LCAN4/0-56-X
Copper Lug - One-Hole, Narrow Tongue, Standard Barrel

SCALE N/A DRAWING NO / CAD FILE LCAN4_0-56-CUST

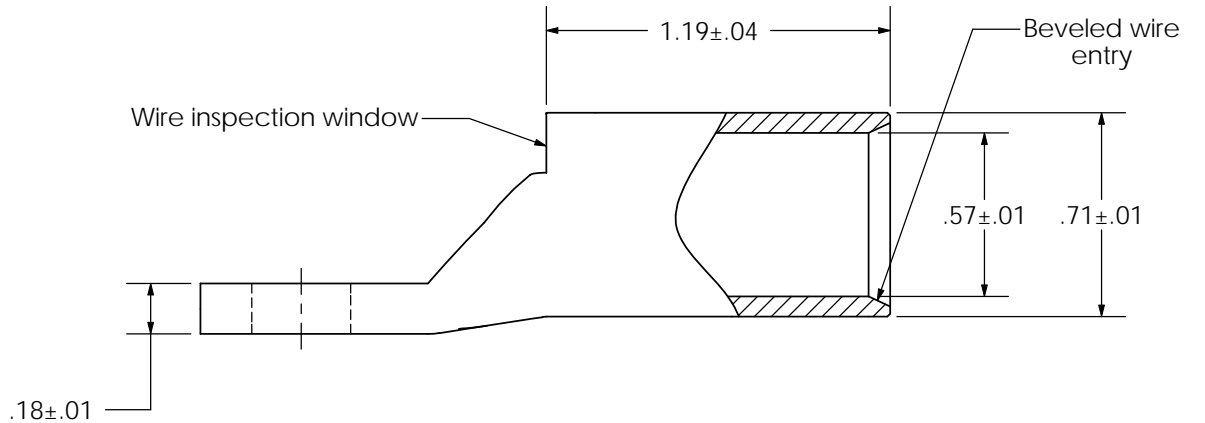
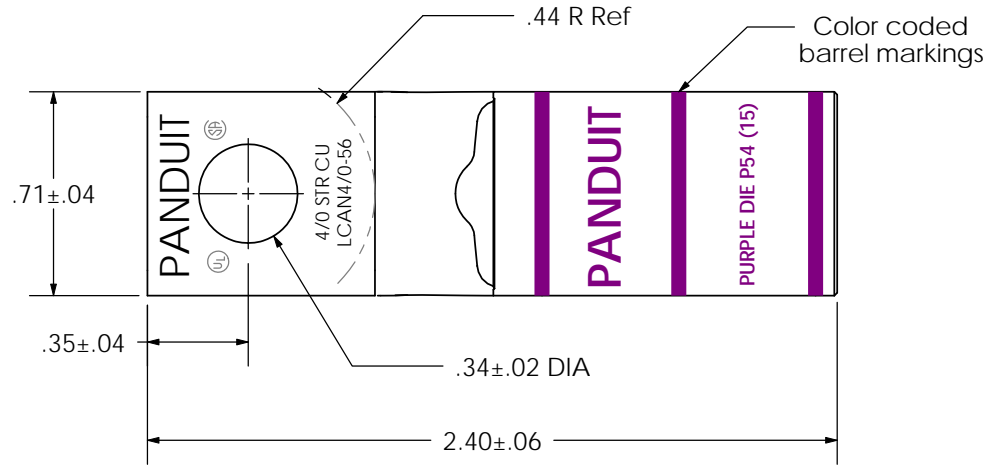
REV	DATE	BY	CHK	DESCRIPTION	ECN	SCALE	DRAWING NO / CAD FILE
01	1/11	JHNU	JHNU	REVISED OVERALL LENGTH: WAS 2.38 REVISED TONGUE THICKNESS: WAS .14		N/A	LCAN4_0-56-CUST
